Solubility

The solubility of actinides is very important to calculating the releases from the repository. The CCA uses a model known as FMT to calculate these solubilities. EEG found that the model predicts differences for actinide sulfate solubilities that cannot be explained by chemistry, thus raising questions about the reliability of this model.

Figure 1. Lease grade potash ore[2] and oil and gas wells.[3]

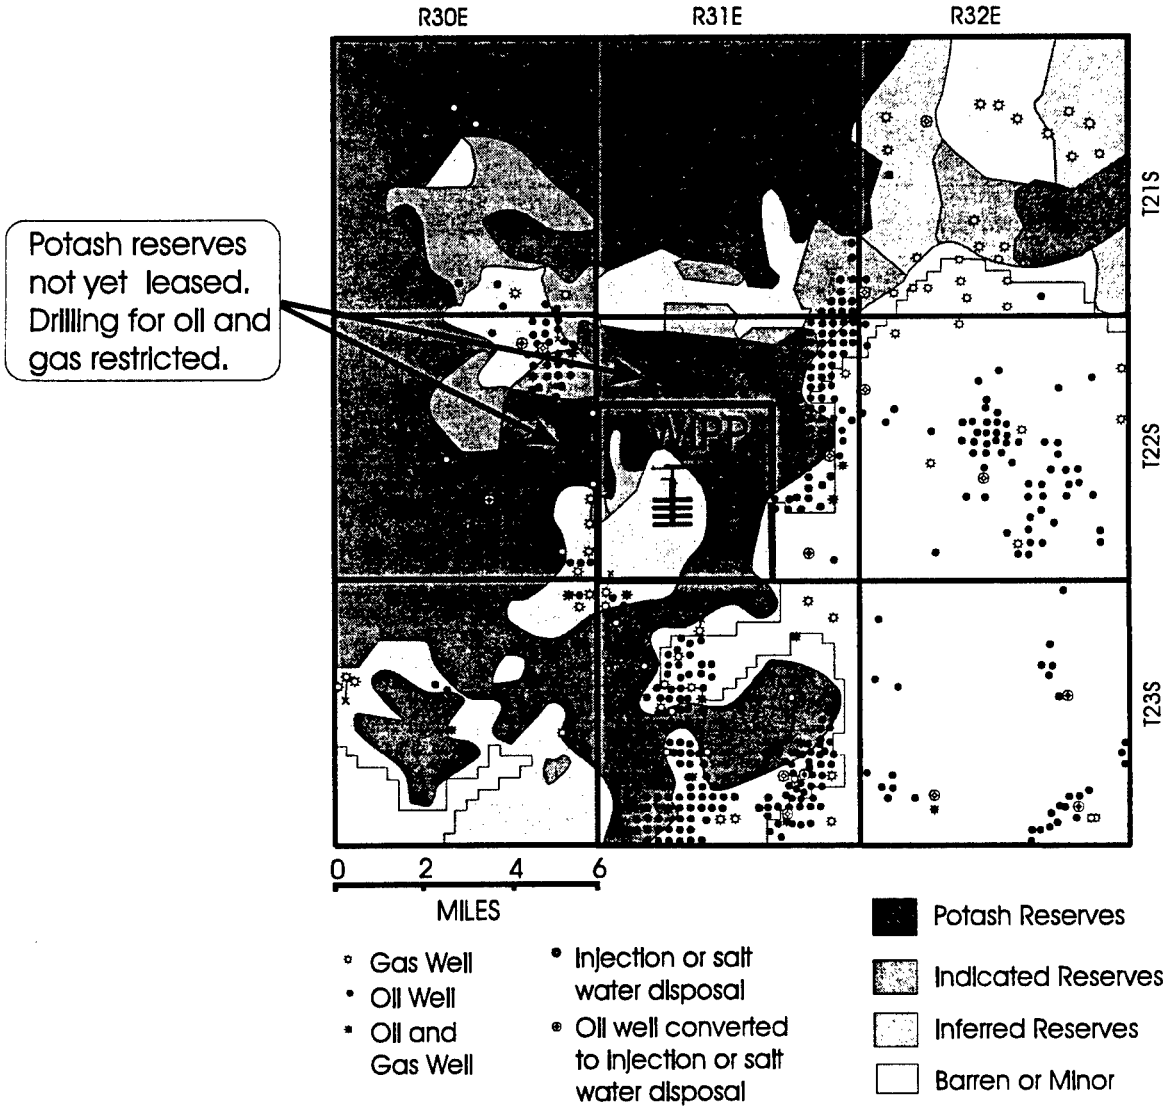
For illustrative purposes, Figure 1 identifies one area of known potash reserves adjacent to the northwest boundary of the WIPP Site. Figure 2 indicates that these potash reserves have not been leased. Potash operators are allowed to hold, directly or indirectly, no more than 51,200 acres in potash permits and leases in a state (43 CFR 3530.3). An operator may not hold all the potash leases he intends to develop (Ref.4, p. 11).

Figure 3. Minable potash.

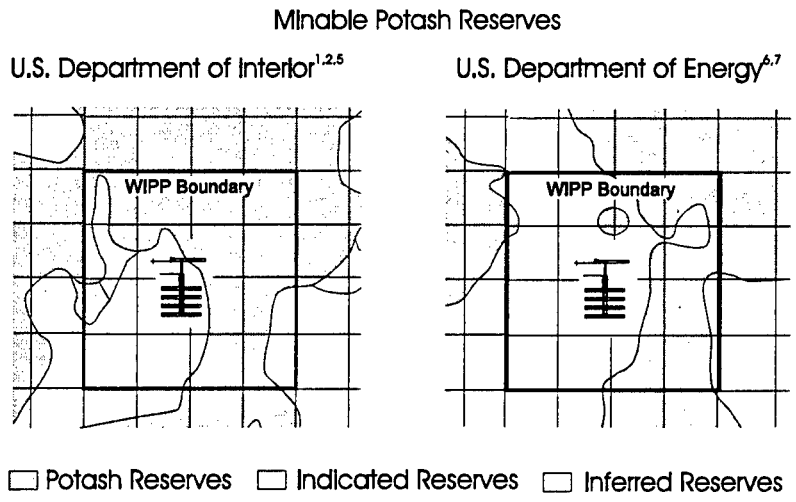
Figure 3 shows the different estimates by DOE and DOI of the extent of minable potash within the WIPP site.

Figure 4. Potash leases within the Delaware Basin and minable potash not yet leased.

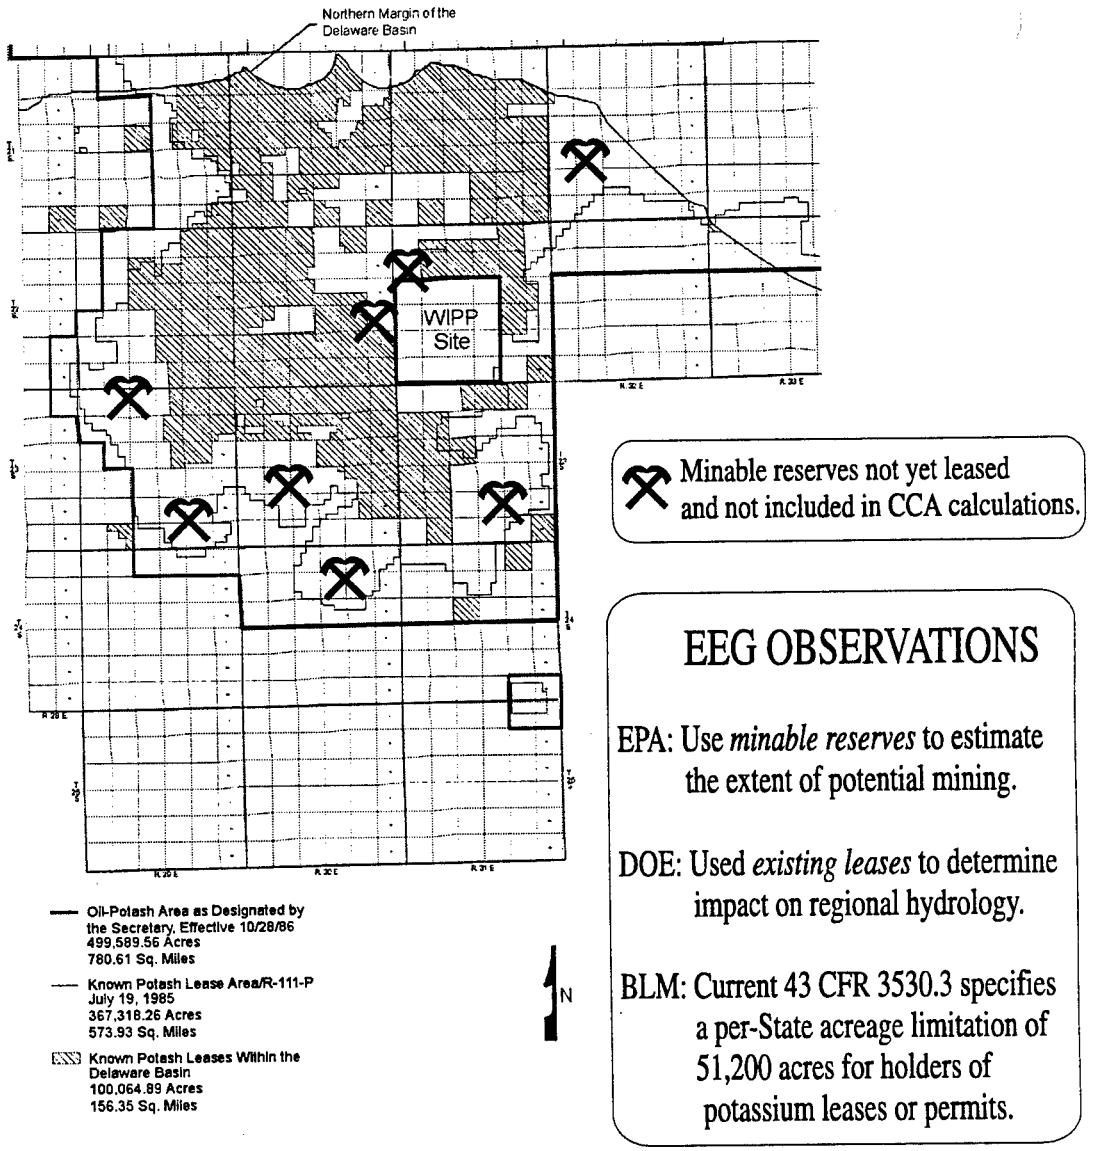
As shown in Figure 4, the CCA does not include the impact of potash mining in unleased areas which will also affect the regional hydrology. 40 CFR Part 194.32 states:

Figure 2: Cumulative Net Brine in and outflow at Repository, FEP S-1 Analysis From Vaughn et al, 1996.

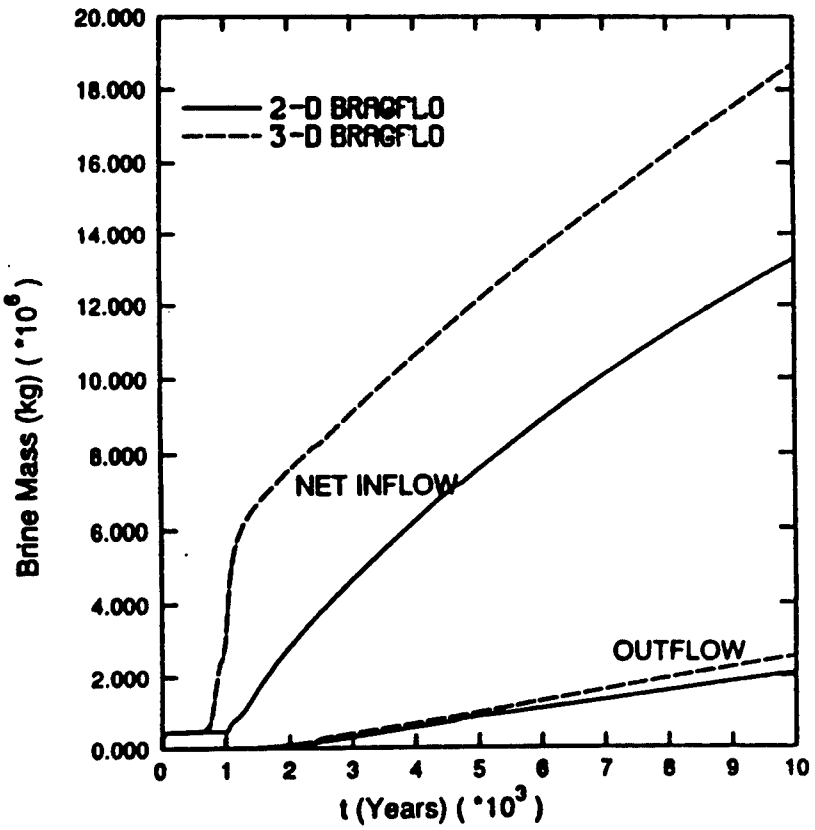
Figure 2 depicts the calculated brine inflow and outflow rates. The figure shows a large difference in calculated inflows of the two models during the period of 700 to 1,000 years. Figure 3 reinforces the perception that the brine inflow in the 3-D model is large. As shown in Figure 3, during the 700 to 1,000 years period the 3-D model shows a decrease in gas saturation of 0.05. Our concern is that if the brine inflow calculated in the 3-D model persists for thousands of years then the 2-D model calculations significantly under-predict repository saturation at high pressures.

Figure 4: Three dimensional scatter plots for volume of brine reaching the surface due to direct brine release for a drilling intrusion into the lower panel.
From Helton, 1996.

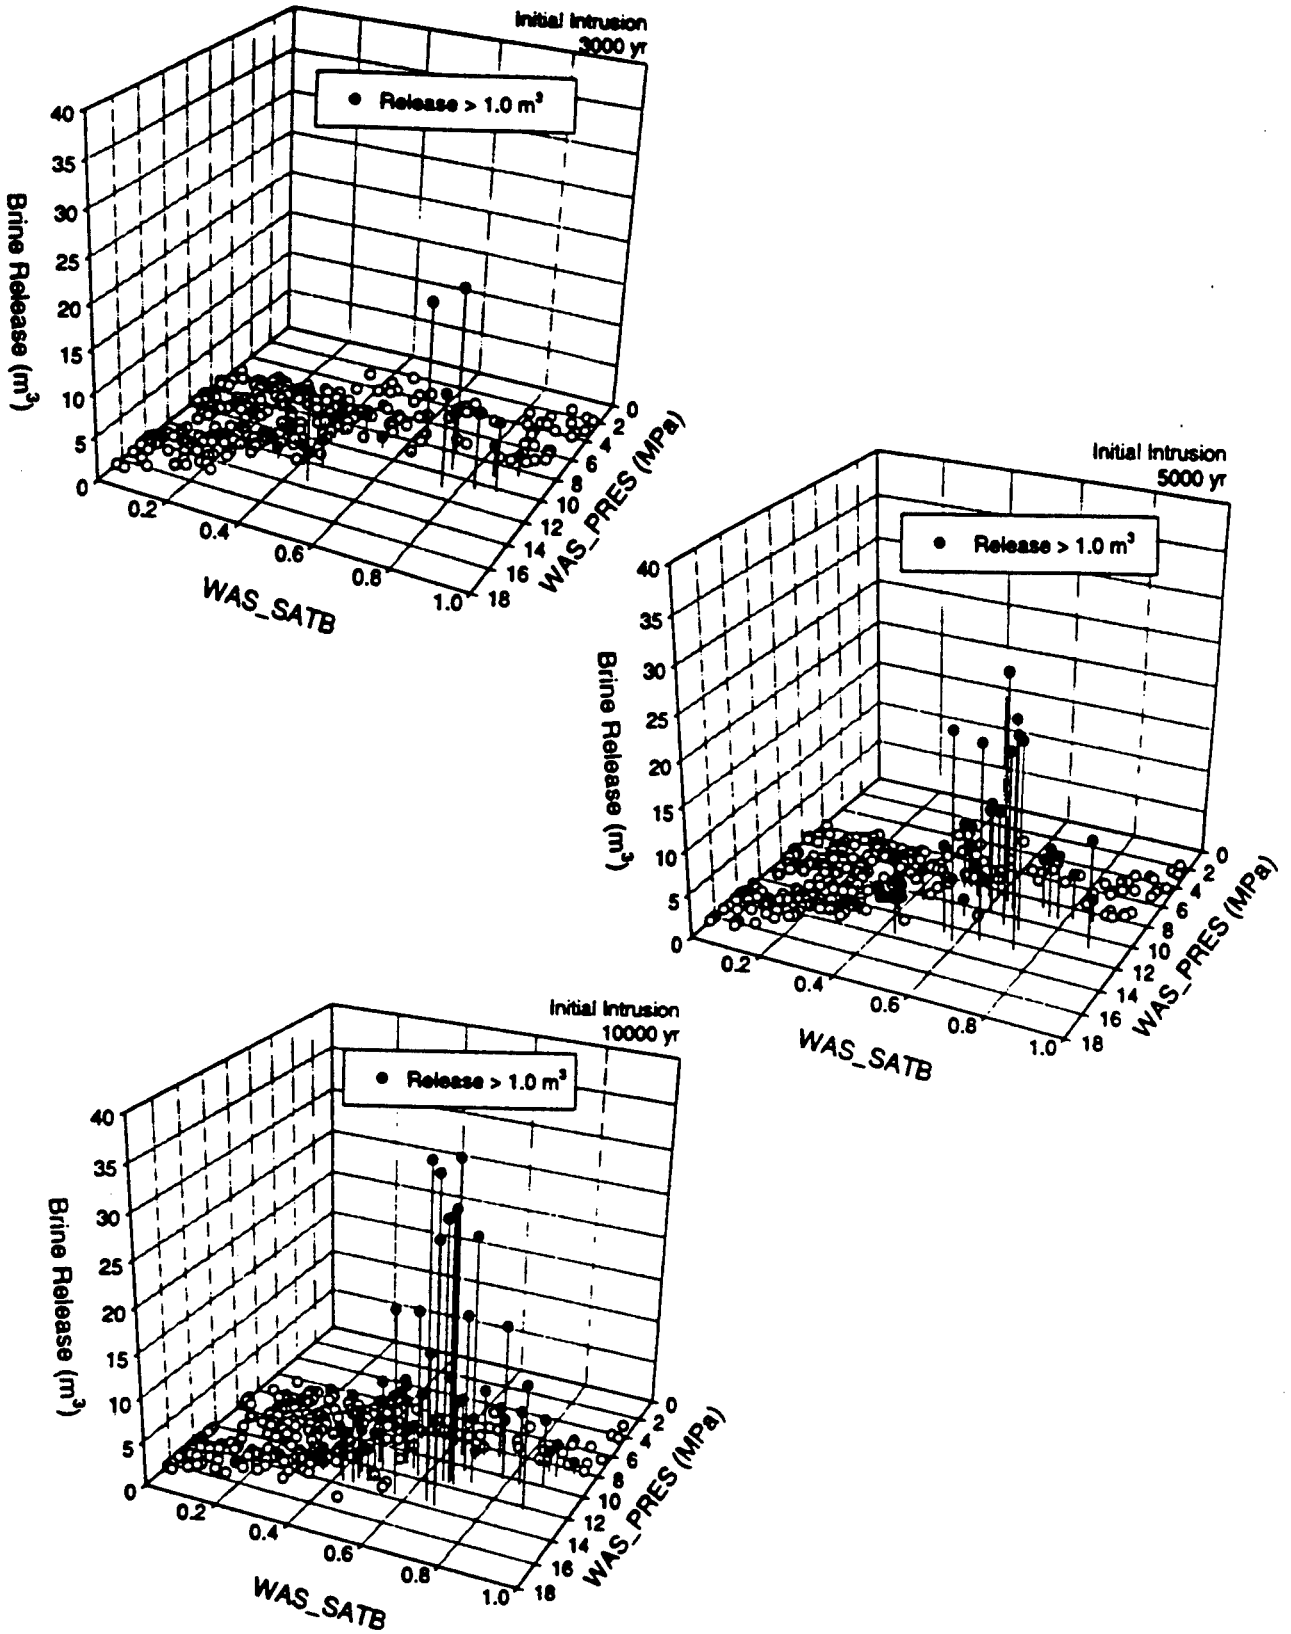
Greater saturations could lead to much larger direct brine release calculations. Figure 4 (Figure 5.1.5 of *Helton)* is the basis of this contention. Figure 4 depicts the relationship of calculated direct brine releases to repository conditions at three separate times. The average repository brine saturation and repository pressure are plotted for each vector on the horizontal plane. A vertical line connects the plane to a small circle at the level of the vertical axis corresponding to the volume of brine calculated to reach the surface. Calculated releases greater than one cubic meter are highlighted using a filled circle.

Figure 4 indicates that there were few calculated direct brine releases when the calculated repository pressures exceeded 12.7 MPa and almost none when the pressure exceeded 14 MPa. Almost all of the larger calculated direct brine releases occurred when brine saturations were above 0.5, a condition never calculated at pressures above 14 MPa. The FEP S-1 analysis suggests that the potential for many of the vectors with great repository pressure to also have large brine saturations. Thus calculated direct brine releases might have both larger volumes and greater frequency in the performance assessment.

Figure 5: Fraction of Initial Iron Remaining in Repository
From: DOE, 1996.

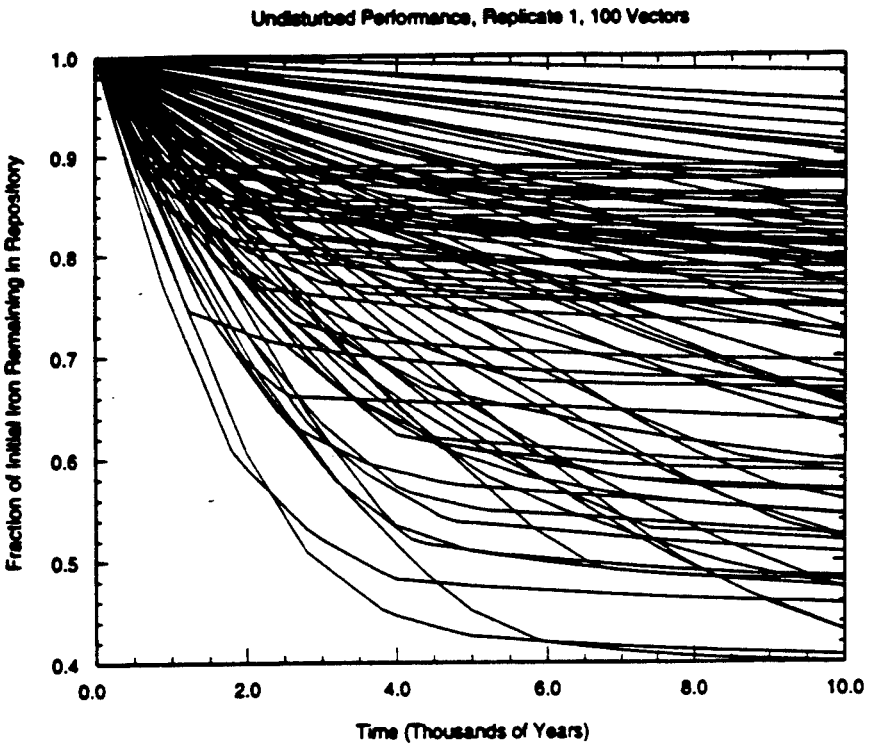
The DOE cites the amount of iron remaining in the repository (Figure 5; *DOE*, 1996 Figure 12-13) as support for the argument that more brine inflow will lead to more gas generation not higher saturations. Figure 6 (Figure 2.2.9 of *Helton*) shows less iron remaining in the lower (waste) panel, presumably due to relatively more brine inflow to the lower panel (Pg 2-18 of *Helton*, 1996). Figure 7 (Figure 2.2.7 of *Helton*, 1996) shows that at most 30,000 cubic meters of brine are predicted to be consumed through iron corrosion. In most vectors, the calculated brine consumption was less than 15,000 m^3. In many, brine consumption continues though-out the 10,000 year compliance period. Other vectors show a secession of brine consumption after less than 2,000 years, presumably due to exhaustion of available brine (See Section 2.2 of *Helton*). Figure 2 suggests that brine inflow from fracturing may be on the order of 10 m^3 / year or more and continue for hundreds to thousands of years. Drawn on the Figure 7 is a line with a slope of 10 m^3 / year. Comparing the brine consumption with this slope indicates that the potential brine flow is large compared to the rate of brine consumption. The potential brine inflow is greater than 10,000 m^3. Most of this flow would likely be into the lower panel. The maximum amount of brine consumed in the lower panel was 6,000 m^3 (Figure 8, Figure 7.2.1-10 of *Bean et al.*).
